STORIE LOU PLAZA JSP20-19

Matter of Consideration at the request of Alrig LLC for approval of the Preliminary Site Plan, Stormwater Management Plan, and Section 9 Façade Waiver. The subject property contains 1.41 acres and is located in Section 14, on the east side of Novi Road, north of Crowe Drive. The site is currently developed with a branch of the Fifth Third Bank. The applicant is proposing to redevelop the site into a 7,000 square foot multi-tenant building that proposes one retail tenant and one restaurant.

PLANNING REVIEW

PLAN REVIEW CENTER REPORT

EAST ELEVATION
SCALE: 1/8" = 1'-0"
AWNING PERCENTAGE: 14%

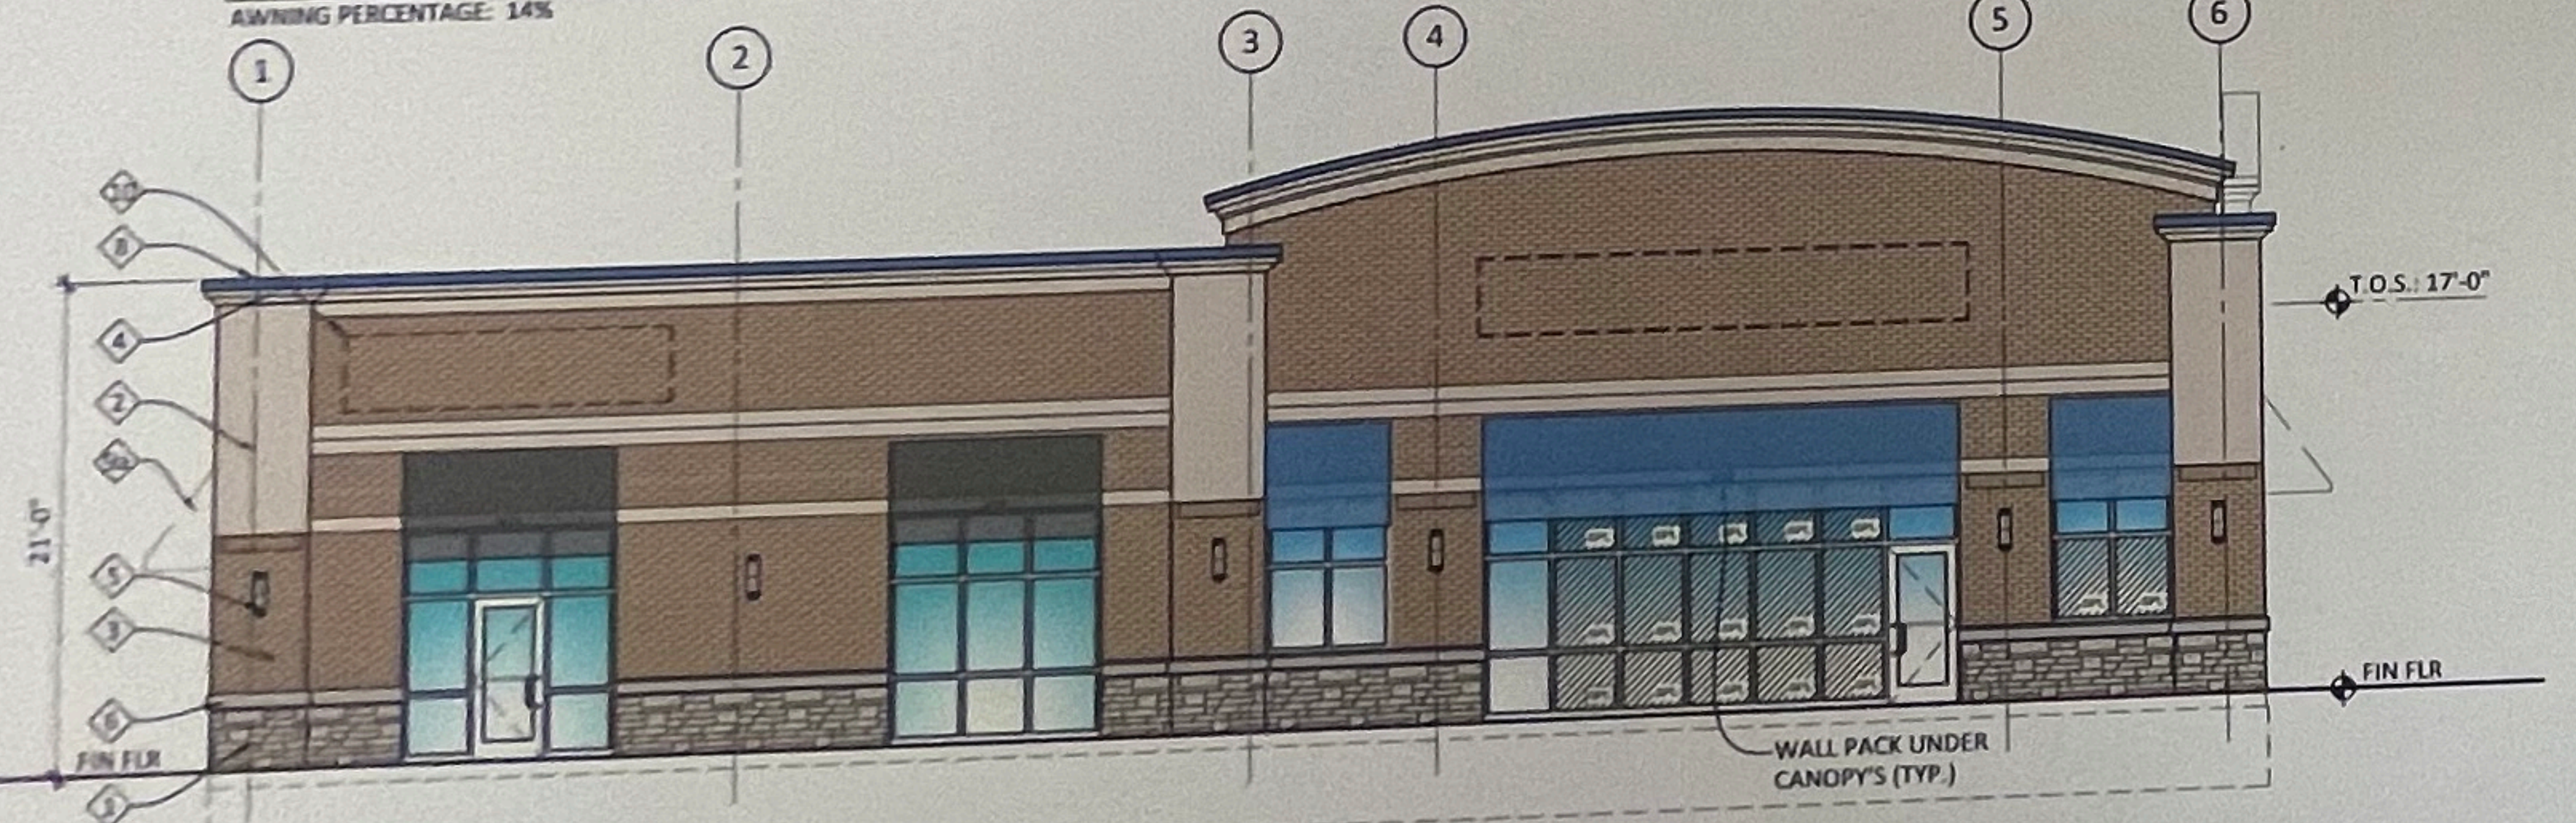
Façade	Approval recommended	10-13-20	<ul style="list-style-type: none"> A Section 9 Façade Waiver is required as the percentage of fabric awning exceeds the maximum percentage allowed (supported by the façade consultant because the proposed materials are consistent with the surrounding area)
Fire	Approval recommended	10-13-20	<ul style="list-style-type: none"> Items to be addressed on the Final Site Plan Submittal

- c. Section 9 Façade Waiver for an overage of fabric awning on the west (10% allowed, 14% proposed), east (10% allowed, 19% proposed), and south (10% allowed, 14% proposed) elevations *because the proposed design does not adversely affect the aesthetic quality and meets the intent and purpose of the Ordinance, which is hereby granted;*
